Normandy Way, Hinckley
Stage 1 Road Safety Audit – Response Report
September 2026
Our Ref: 29480-TRAN-0803 Rev A

Report Title:	Stage 1 Road Safety Audit Response Report
Date:	September 2026
Document Reference and Revision:	29480-TRAN-0803
Prepared By:	Dave Godber
On Behalf Of:	MEC Consulting Group Ltd

STAGE 1 – ROAD SAFETY AUDIT

REPORT REF: 26-2400-RSA1

3.2. Problem 1

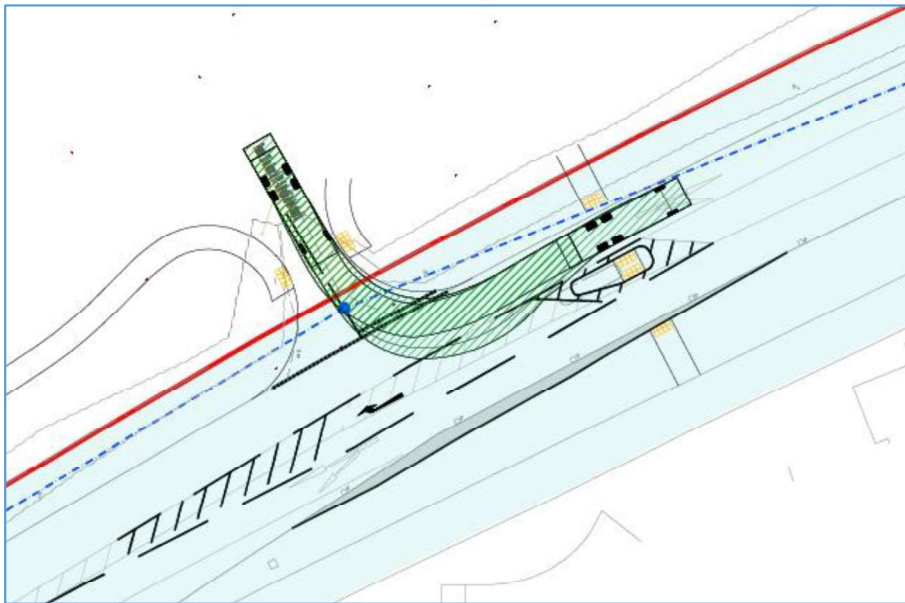
Location: Proposed ghost right turn lane.

Summary: Short deceleration lane risks shunt type collisions.

The Transport Statement shows westbound 85th percentile speeds of over 40mph. However, the design includes a deceleration lane of 15m, below the minimum standard shown within CD123. This is likely to result in right turners slowing significantly within the westbound lane, risking shunt type collisions either on the approach or potentially within the right turn facility.

It is recommended that a deceleration lane in line with the design standards is provided.

RSA Problem	RSA Recommendation	Design Organisation Response	Overseeing Organisation Response	Agreed RSA Action
<i>Location: Proposed ghost right turn lane.</i> <i>Summary: Short deceleration lane risks shunt type collisions.</i> <i>The Transport Statement shows westbound 85th percentile speeds of over 40mph. However, the design includes a deceleration lane of 15m, below the minimum standard shown within CD123. This is likely to result in right turners slowing significantly within the westbound lane, risking shunt type collisions either on the approach or potentially within the right turn facility.</i>	<i>It is recommended that a deceleration lane in line with the design standards is provided.</i>	It is not feasible to provide a right-turn deceleration lane of the length recommended by the Audit Team whilst maintaining both the 100m eastbound merge length from the signal-controlled Normandy Way / Ashby Road junction and the existing right-turn lane serving Cornwall Way, as required by LCC. The proposed access has therefore been positioned as far west as practicable. Drawing No. 29480_08_020_04 Revision D shows the resulting arrangement. The proposed development is forecast to generate 3 and 7 No. right turn arrivals during the AM and PM peak hours respectively. At the higher forecast flow, this equates to approximately 1 No. right-turning vehicle every 9 No. minutes on average. Vehicles are currently required to turn right into the site without the benefit of a dedicated right-turn facility. The proposed arrangement would therefore provide an improvement over the existing situation whilst increasing deceleration length currently available for these manoeuvres. On balance, the Design Organisation considers that the proposed arrangement represents the best practicable solution within the identified highway constraints. This response and any associated departure from standard are submitted to the Overseeing

3.3. Problem 2

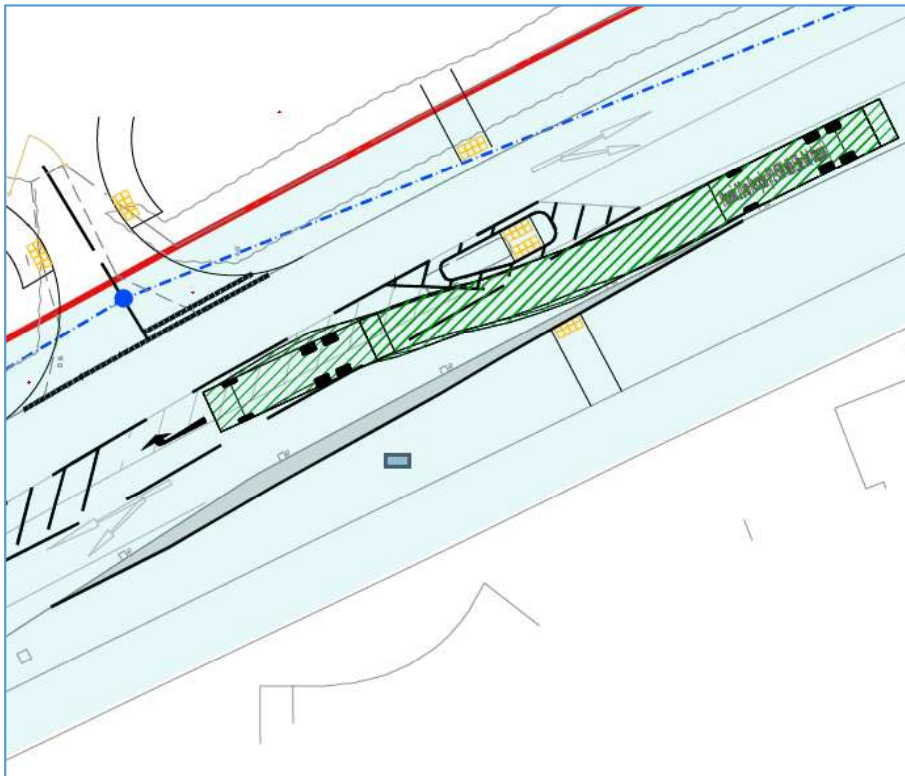
Location: Site access.

Summary: Exiting refuse vehicles oversailing the right turn lane risk shunts / offside collisions.

The swept path analysis shows that left turning refuse vehicles will oversail the right turn lane when exiting the site. Should a right turner be present or approaching the junction there is a risk of sudden braking, resulting in shunt type collisions, or in offside to offside collisions.

It is recommended that the junction radius is amended so that exiting vehicles do not oversail the right turn lane on exiting the site.

RSA Problem	RSA Recommendation	Design Organisation Response	Overseeing Organisation Response	Agreed RSA Action
		Organisation for consideration and agreement.		
<i>Location: Site access.</i> <i>Summary: Exiting refuse vehicles oversailing the right turn lane risk shunts / offside collisions.</i> <i>The swept path analysis shows that left turning refuse vehicles will oversail the right turn lane when exiting the site. Should a right turner be present or approaching the junction there is a risk of sudden braking, resulting in shunt type collisions, or in offside to offside collisions.</i>	<i>It is recommended that the junction radius is amended so that exiting vehicles do not oversail the right turn lane on exiting the site.</i>	Accepted: The eastern side junction radius has been increased to 10.0m along with a 1-in-5 taper to allow an exiting 11.220m length refuse vehicle not to oversail the proposed right-turn lane, as shown on Drawing No 29480_08_020_04 Revision D in Appendix C. This is proposed for agreement with the Overseeing Organisation.

3.4. Problem 3

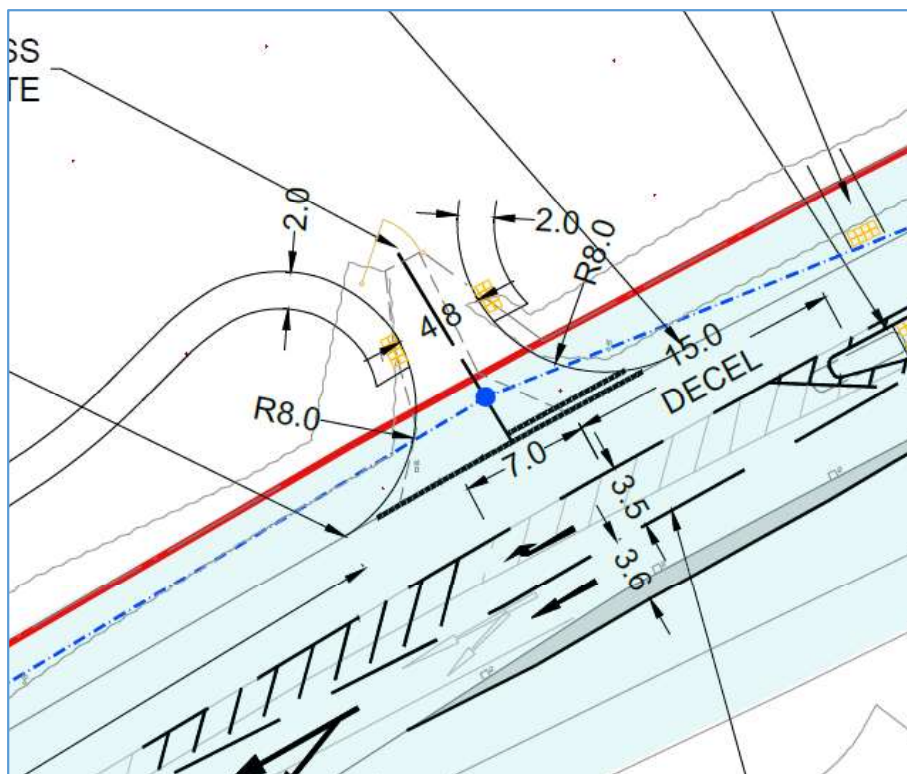
Location: Site access.

Summary: Overhanging refuse vehicle risks shunt type collisions.

When entering the right turn lane, the refuse vehicle passes close to the amended refuge. Should the driver shy away from the kerbed feature, which is likely, there is a risk that the vehicle will overhang the westbound lane risking being struck by following westbound vehicles.

It is recommended that the refuge is amended to allow the refuse vehicle to sit within the right turn lane.

<i>Location: Site access.</i> <i>Summary: Overhanging refuse vehicle risks shunt type collisions.</i> <i>When entering the right turn lane, the refuse vehicle passes close to the amended refuge. Should the driver shy away from the kerbed feature, which is likely, there is a risk that the vehicle will overhang the westbound lane risking being struck by following westbound vehicles.</i>	<i>It is recommended that the refuge is amended to allow the refuse vehicle to sit within the right turn lane.</i>	Accepted: The refuge has been narrowed at the western end to provide additional space for a refuse to fully enter the right-turn lane while waiting to turn right into the development without overhanging the westbound carriageway lane, as shown on Drawing No. 29480_08_020_04 Revision D in Appendix C. This is proposed for agreement with the Overseeing Organisation.		
<i>Location: Site access.</i> <i>Summary: Slow / delayed left turning vehicles risk shunt type collisions.</i> <i>It was noted that eastbound 85th percentile speeds are around 40mph, and that the access is located at the end of the eastbound merge from the signalised junction to the west. Should drivers have to decelerate to a significantly slow speed in order to enter the junction, especially in the</i>	<i>It is recommended that a swept path analysis is undertaken for a typical large car in the presence of a vehicle waiting at the give way line, checking that it is able to pass uninhibited. Should this not be the case it is recommended that the dimensions of the junction are amended.</i>	Accepted: Additional tracking has been undertaken to demonstrate that a large estate car turning left into the site can pass another large estate car waiting at the give way line to turn right out of the site, as shown on Drawing No. 29480_08_020_04 Revision D in Appendix C. This is proposed for agreement with the Overseeing Organisation.

3.5. Problem 4

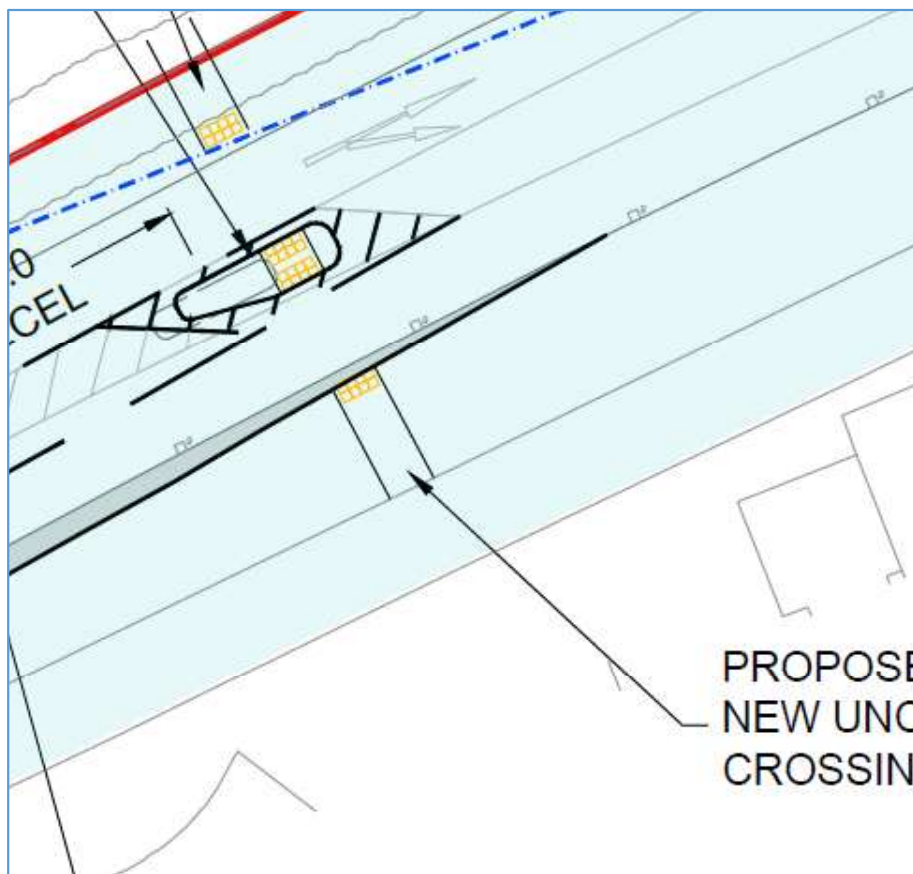
Location: Site access.

Summary: Slow / delayed left turning vehicles risk shunt type collisions.

It was noted that eastbound 85th percentile speeds are around 40mph, and that the access is located at the end of the eastbound merge from the signalised junction to the west. Should drivers have to decelerate to a significantly slow speed in order to enter the junction, especially in the presence of a vehicle waiting to exit from the site, there is an increased risk of shunt type collisions here.

It is recommended that a swept path analysis is undertaken for a typical large car in the presence of a vehicle waiting at the give way line, checking that it is able to pass uninhibited. Should this not be the case it is recommended that the dimensions of the junction are amended.

RSA Problem	RSA Recommendation	Design Organisation Response	Overseeing Organisation Response	Agreed RSA Action
presence of a vehicle waiting to exit from the site, there is an increased risk of shunt type collisions here.

Appendix C

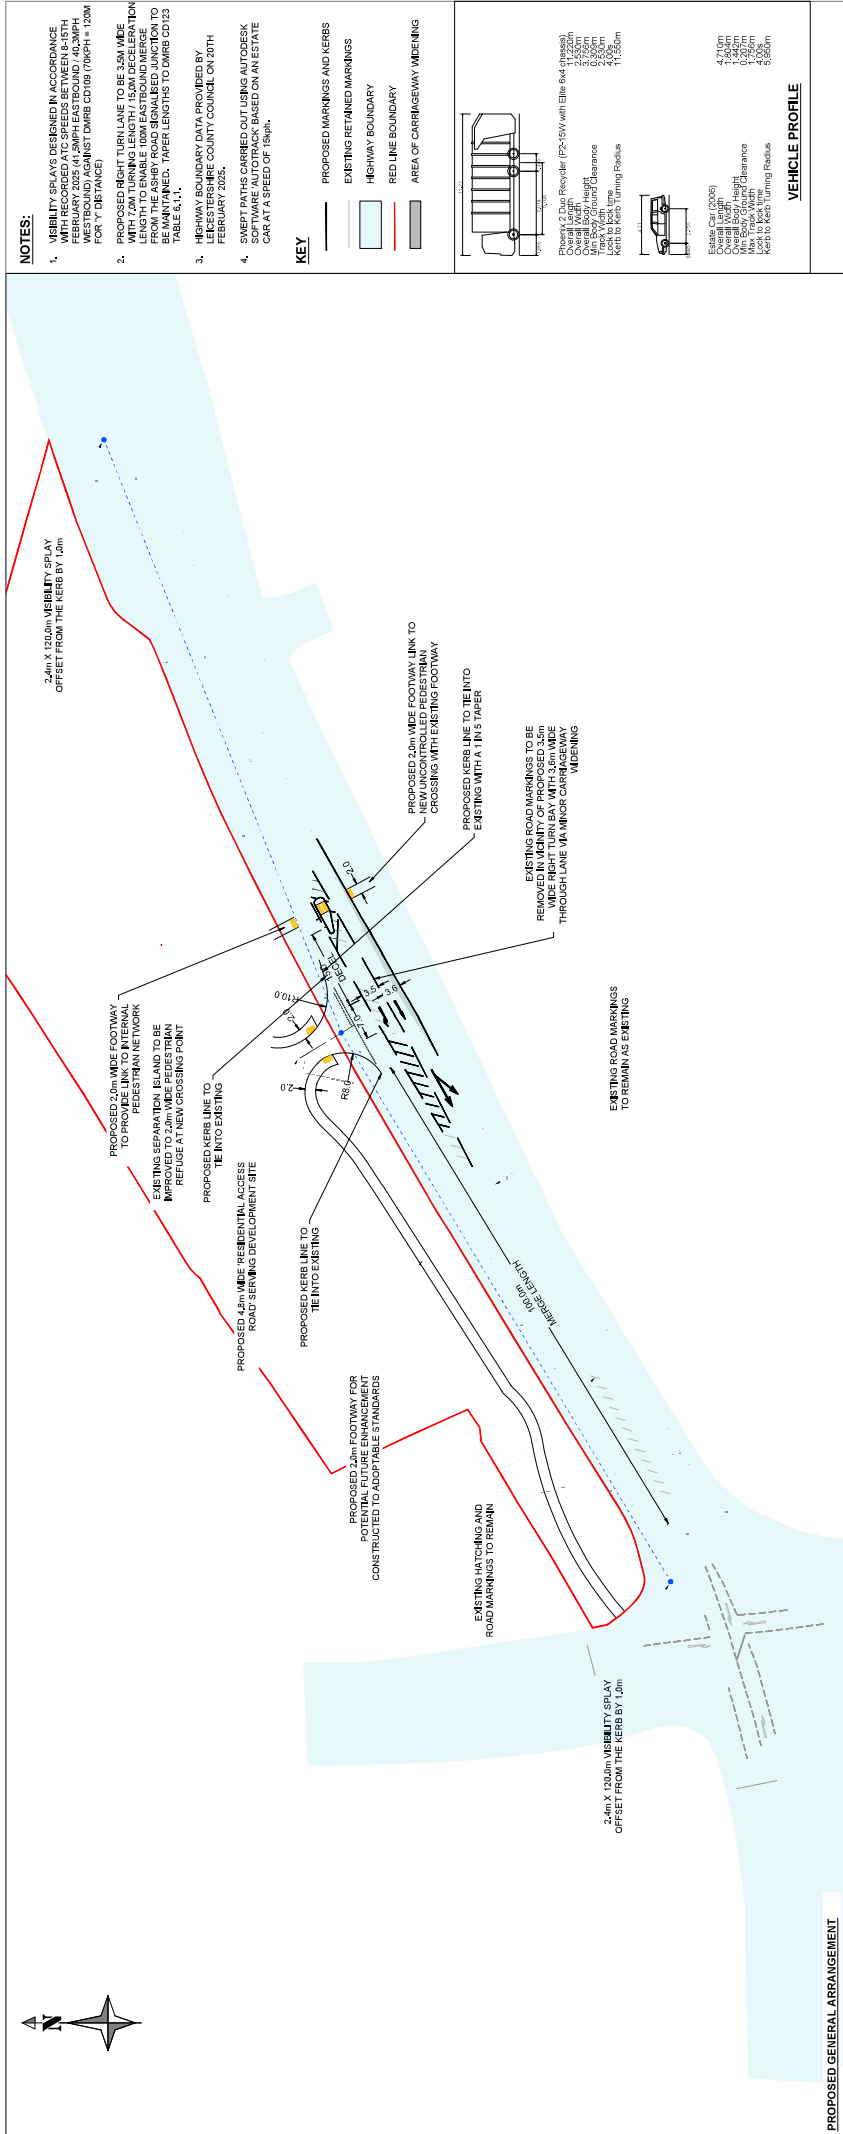
“Observation 1: Whilst it is appreciated that the design is in a preliminary phase, it was observed that tactile paving to a depth of 800mm is shown on the approaches to the proposed pedestrian crossing to the east of the junction. As the crossing is inline with the approaching footways on both sides, it is recommended that tactile paving to a depth of 1,200mm is provided through the detailed design.”

Response: The depth of the tactile paving has been increased to 1200mm as shown on Drawing No. 29480_08_020_04 Revision D in Appendix C.
